Access Compliance Report

Public Rights-of-Way

(Pedestrian Signals)

Intersection ID: N/A	Main Street:	Cross Street: N/A	Location: N/A
ADA ID: 9AC4BD44FB67	Signal Type: One Push Button-APS	Overall Compliance: No	Severity Score: BTN 1: N/A BTN 2: N/A No BTN: N/A
Codes/Mitigation Info/Possible Solution		Field Measurements/Component Compliance

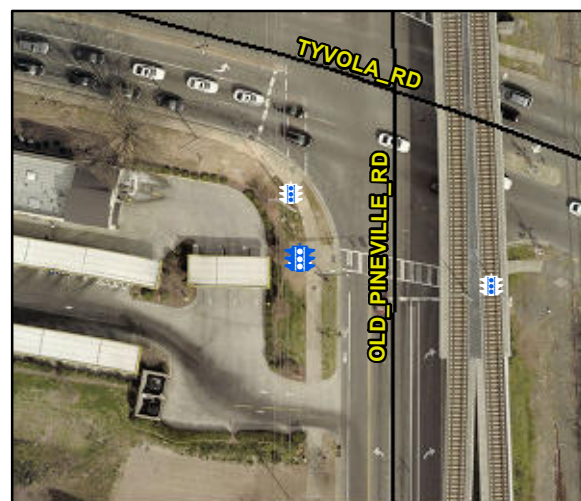
Yes B 1 Clear Xing Direction?	ClearlyMarked	N/A B 2 Clear Xing Direction?	N/A
B 1 Crossing Direction	To E	B 2 Crossing Direction	N/A
Yes B 1 DistanceTo XWalk (in)	0.0	N/A B 2 DistanceTo XWalk (in)	N/A
No B 1 DistanceTo Curb (in)	202.0	N/A B 2 DistanceTo Curb (in)	N/A
Yes B 1 Diameter (in)	2.0	N/A B 2 Diameter (in)	N/A

Possible Solutions: Replace Signal Push Button With APS Button on New Post. Remove & Relocate Sign.
